STERLING RANCH ROAD & BRIARGATE PARKWAY STORM PLANS

STORM SEWER PLANS

PCF FILING NO.: CDR 221

v4_CDs Storm.pdf Markup Summary

DP18 PROFILE(2)
STA 15+00.00 TO 20+50.00
PUBLIC

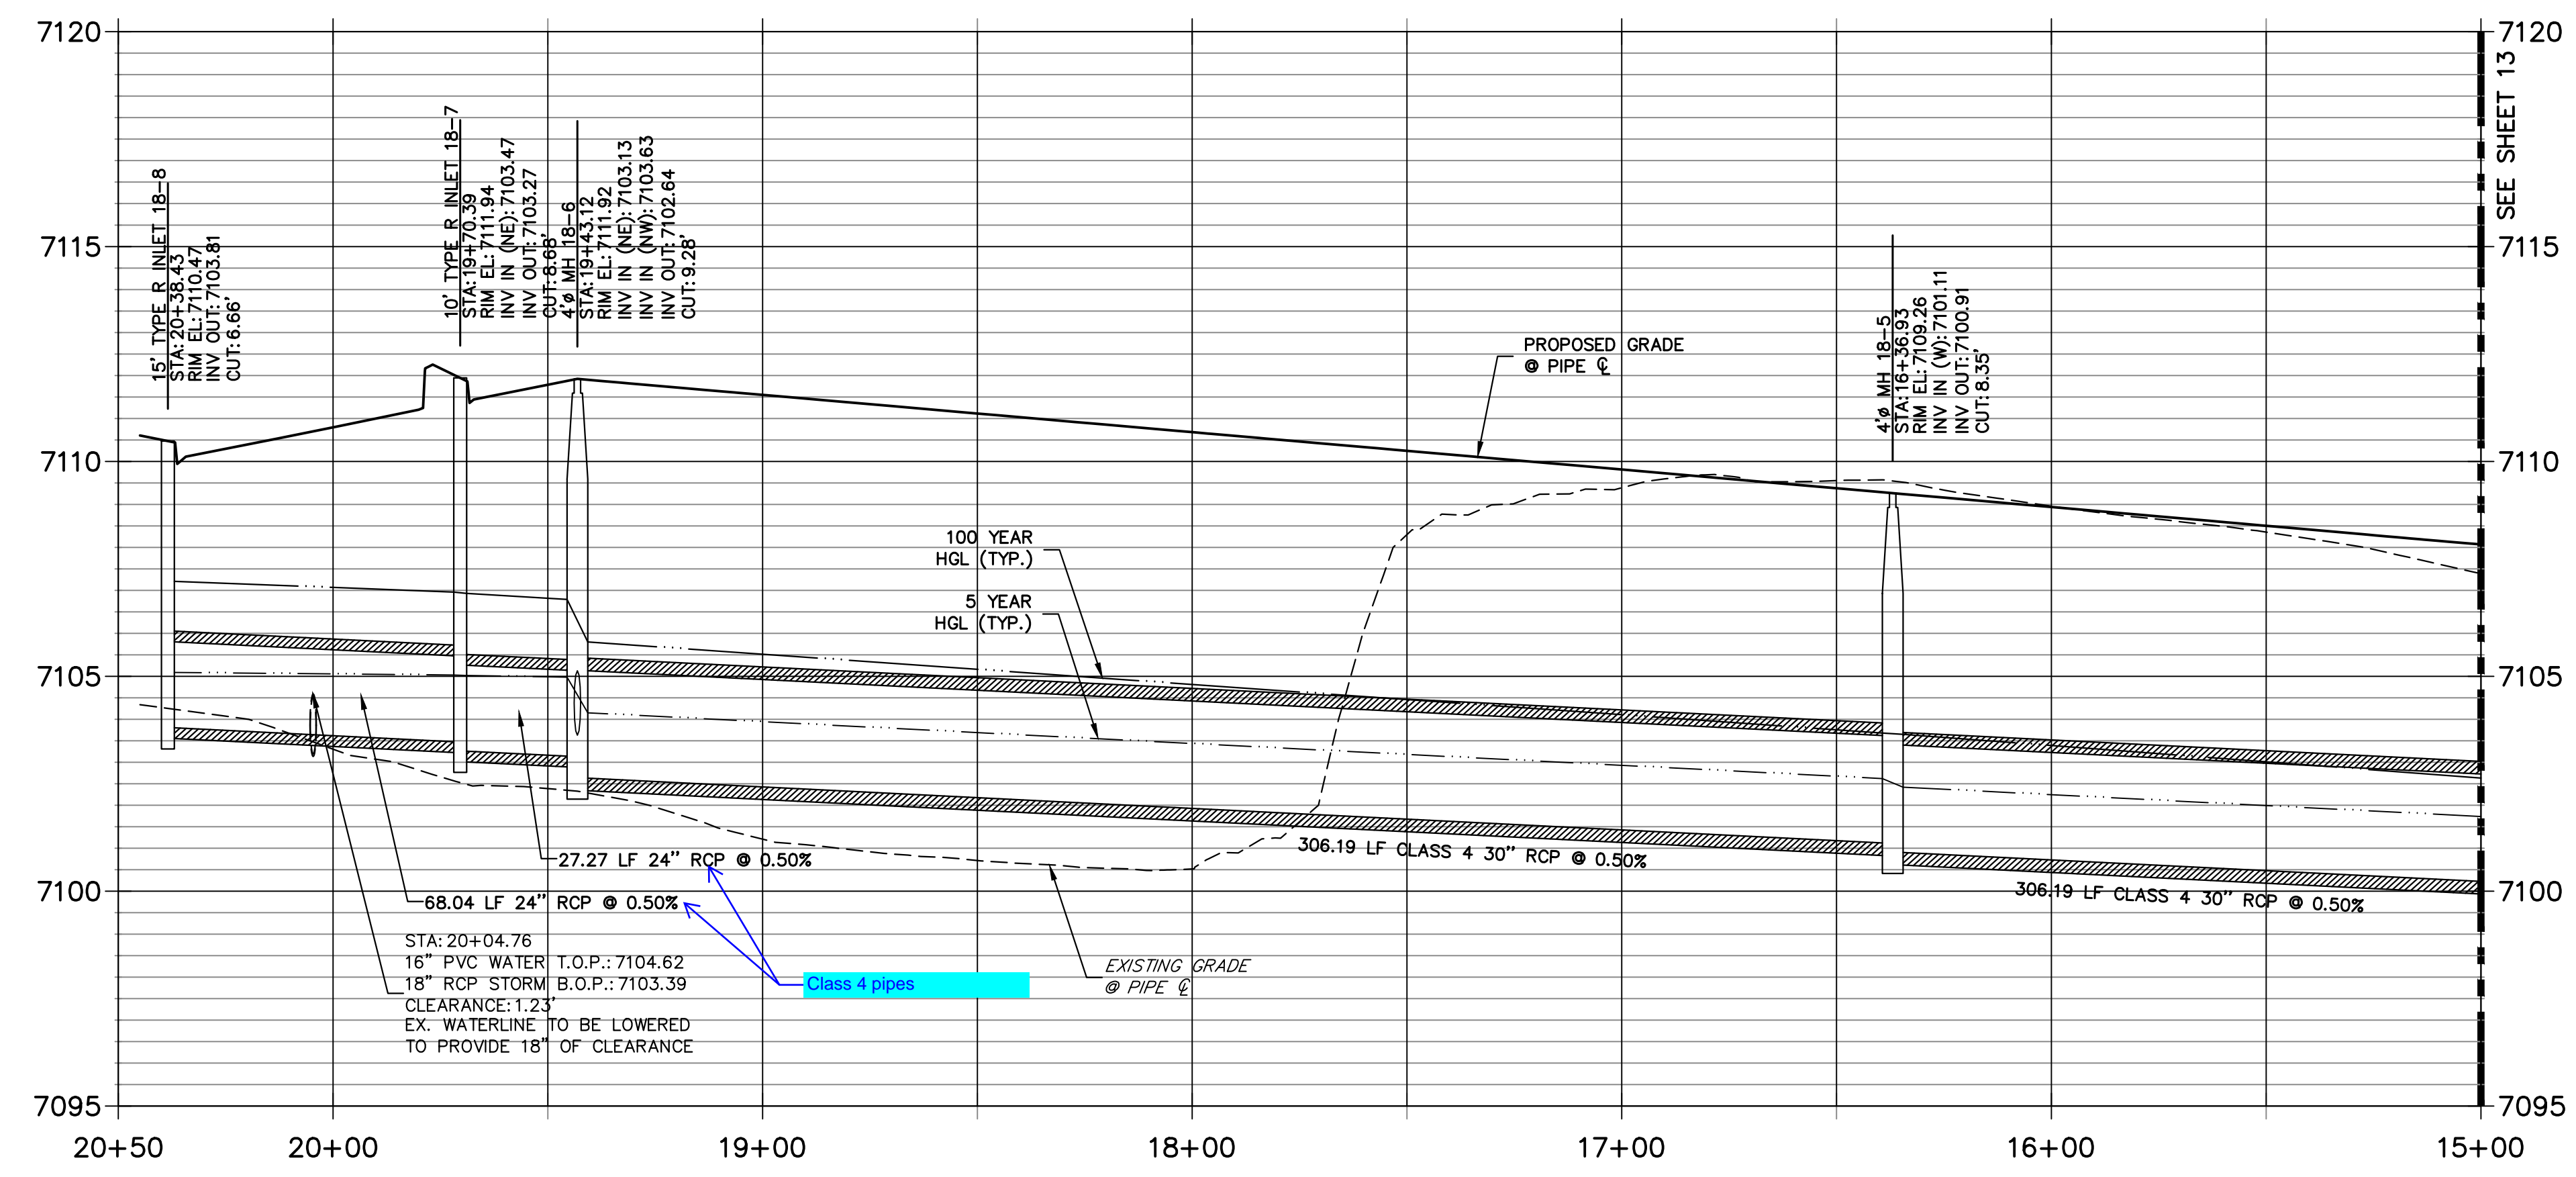
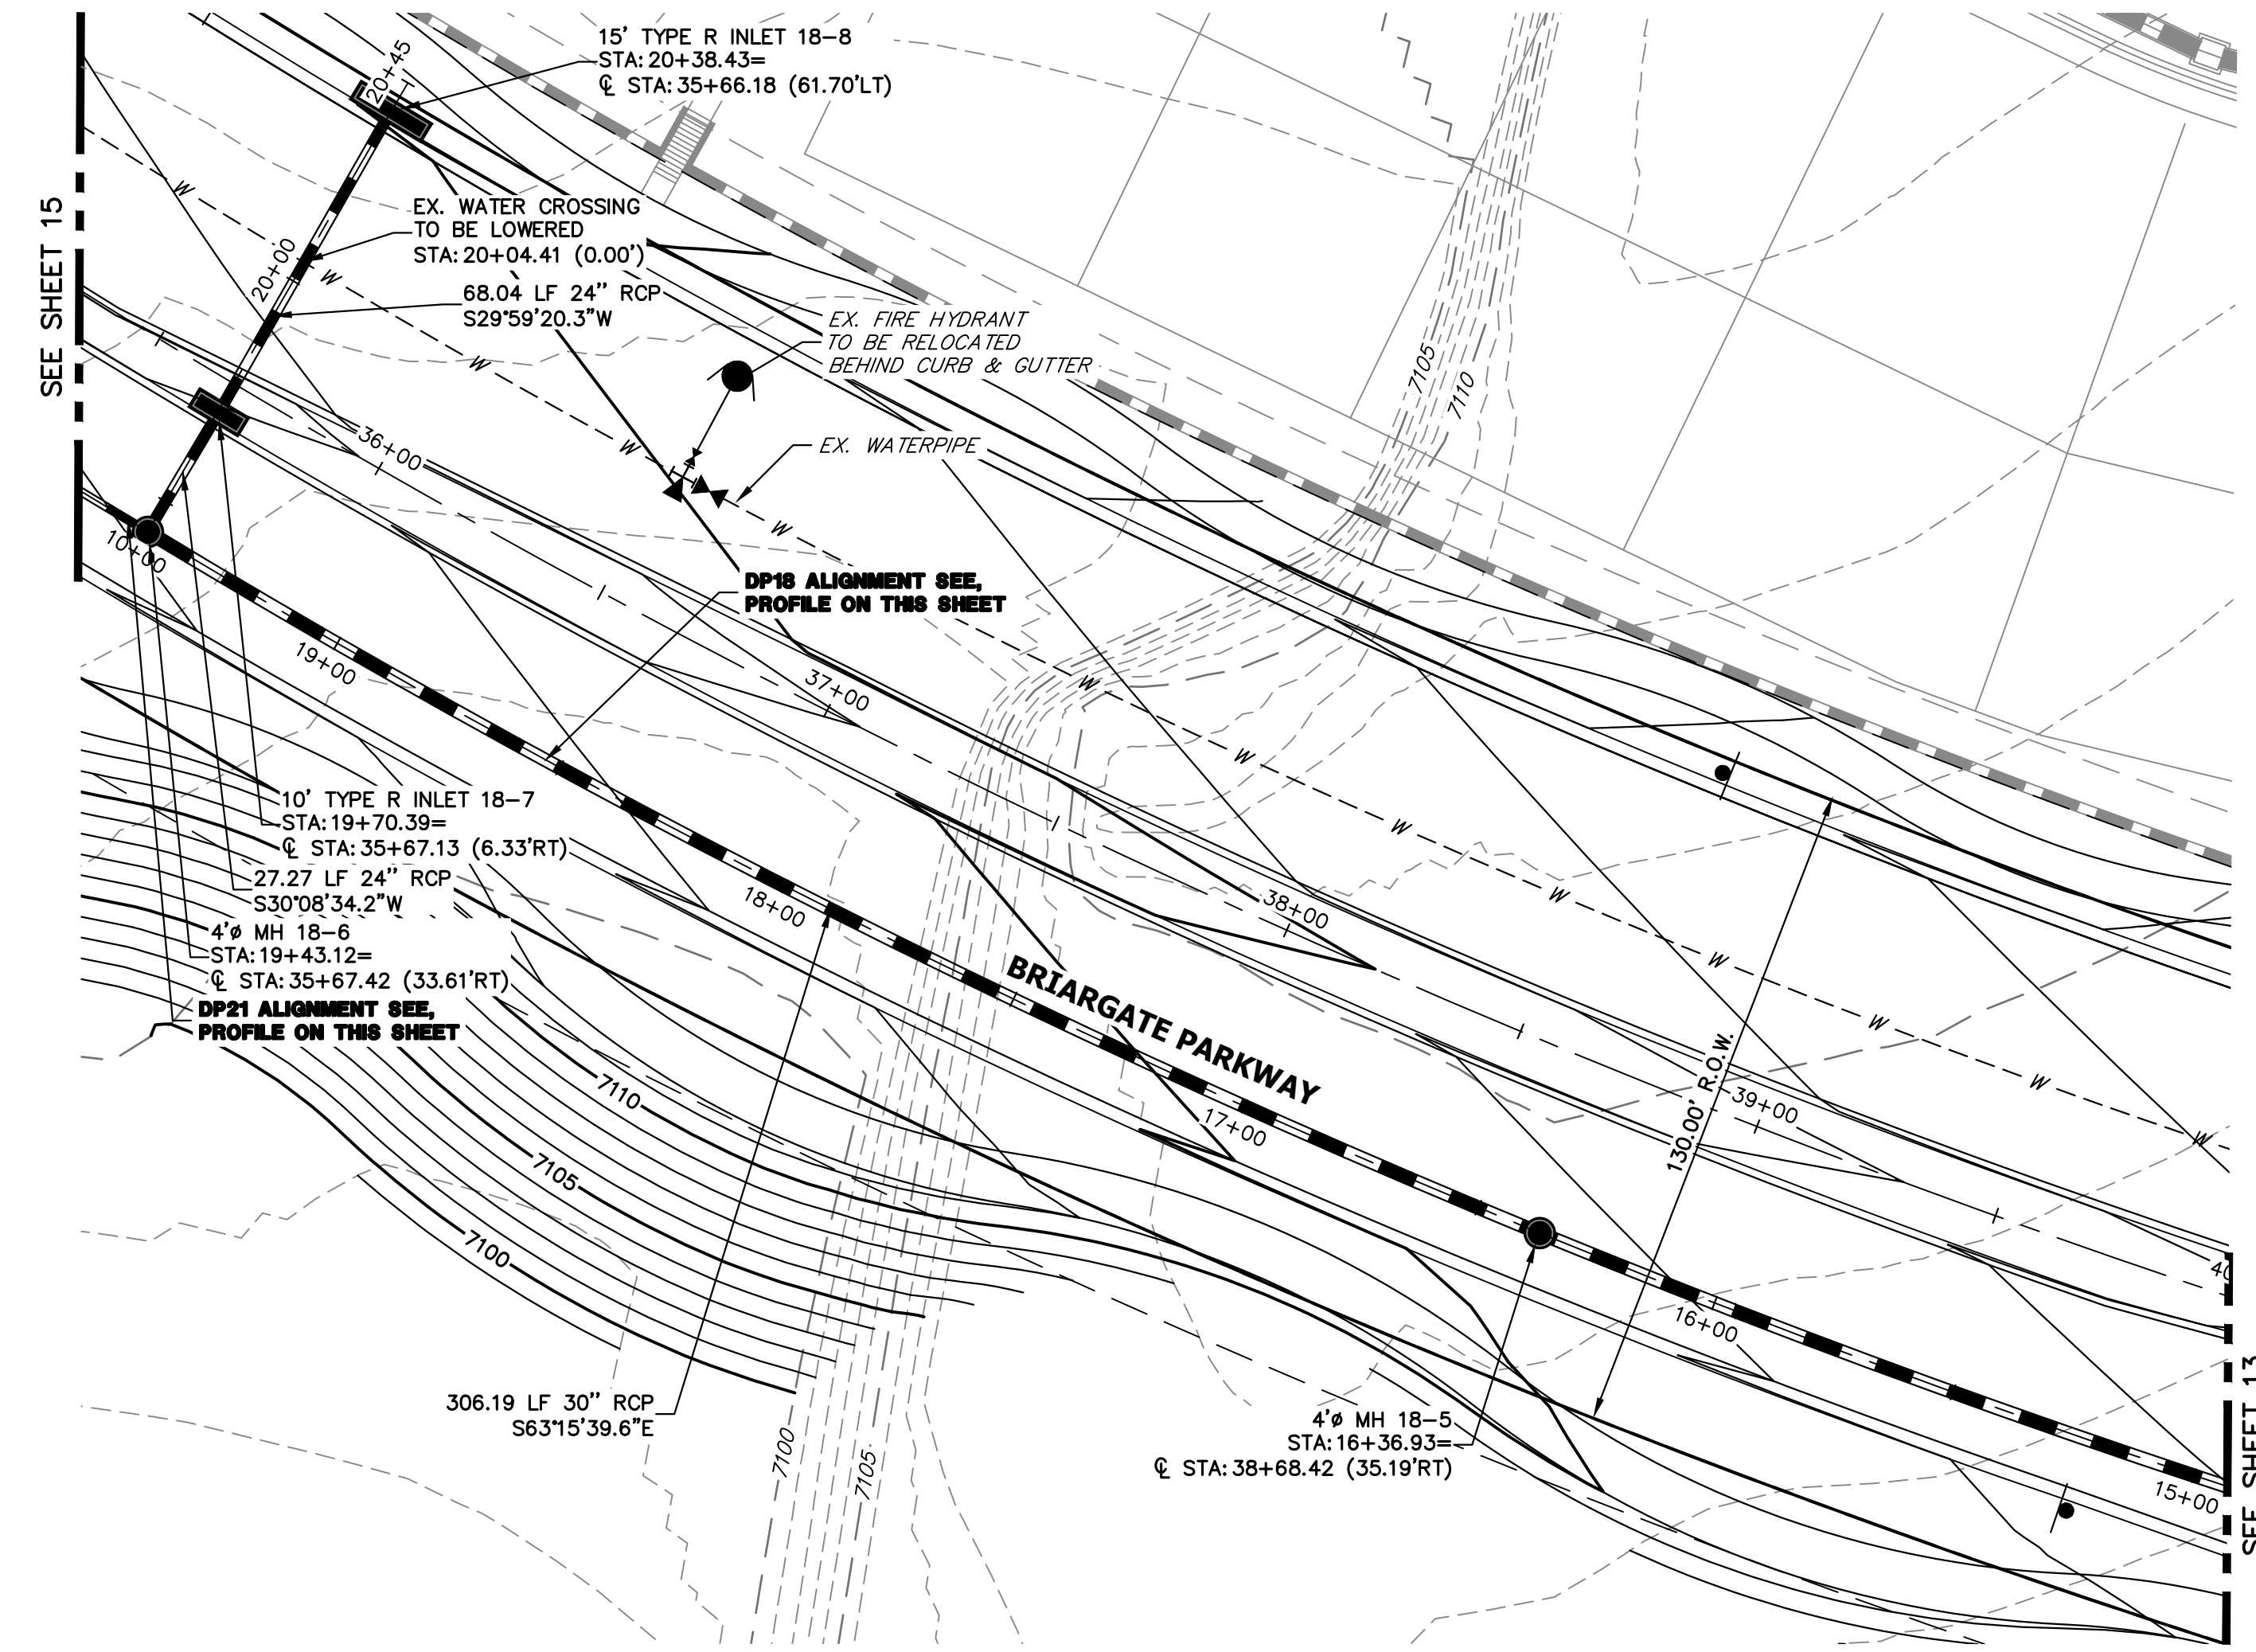
Label break in pipe

Per stormCAD pipe sizes on this sheet are 24".
 Pipes should also be Class 4, since located within
 Briargate Pkwy

Label break

Briargate Parkway
